**COLUMBIA COUNTY PLANNING COMMISSION  
STAFF REPORT**

**FILE NUMBER:** S 21-01

**REQUEST:** To partition the ± 10.08 acre subject property into five parcels of approximately 2.0 acres.

56627 HAZEN ROAD SUBDIVISION  
COLUMBIA COUNTY, OR  
COVER SHEET

**STORMWATER PLAN**  
SCALE: 1" = 50'

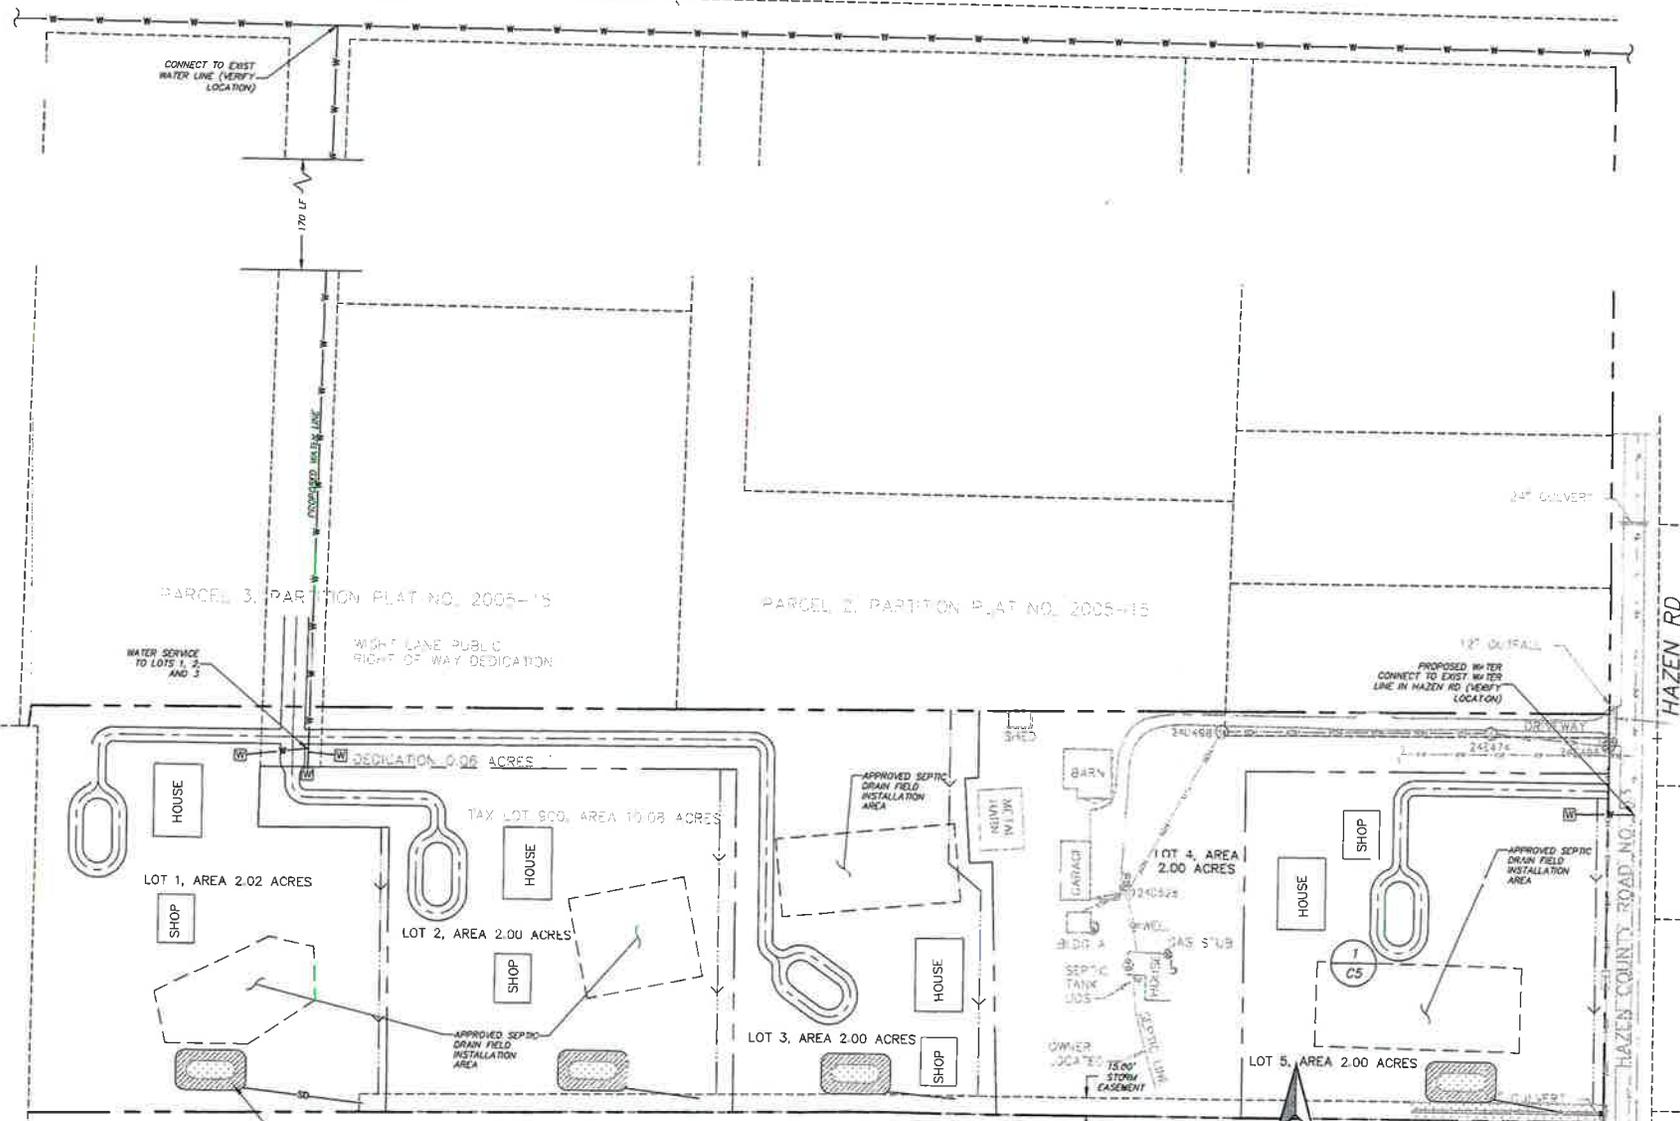
As stated previously, the applicant has obtained septic lot evaluations for all four undeveloped lots. The County Sanitarian submitted comments and stated that the development plan is consistent with septic site evaluation approvals. However, the proposed stormwater detention ponds and swales create a 50 foot setback from the septic areas and may need to be relocated to achieve requirements. Staff would also like to note that the proposed stormwater detention ponds, as shown on the Grading and Erosion Control Plan are located in the middle of all proposed, undeveloped lots on the southern property line. It appears that there will be at least one conflict with the proposed physical development of Lot 3 and the stormwater detention pond as shown. It does not look feasible to access the “Shop” structure with the stormwater detention pond as shown. In order to achieve the required 50 foot setbacks to all septic infrastructure, as well as maximize the useable space on each lot, staff recommends locating these stormwater detention ponds to the corners of each proposed lot.

Staff would also recommend that the applicant add a stormwater detention pond to proposed Lot 4. While this lot will contain all of the existing development located on the 10.08 acre property, there is still stormwater that is generated from the impervious surfaces that is directed to the existing ditch on the south property line. In order to control this stormwater, a detention pond is needed on proposed Lot 4.

**Columbia County Sanitarian:** Development site plan is consistent with septic site evaluation approvals. Proposed stormwater detention ponds and swales create a 50 foot setback and may need to be relocated to achieve requirements.

4. The stormwater plan is acceptable, however we did not see infiltration mentioned in it. Will there be infiltration in the detention ponds?

- d. The applicant shall submit a revised review copy of the preliminary plat showing the updated location of the stormwater detention ponds in relation to the septic approval areas. This revised stormwater plan shall also add a stormwater detention pond for proposed Lot 4. This shall be reviewed by the project planner and the County Sanitarian.
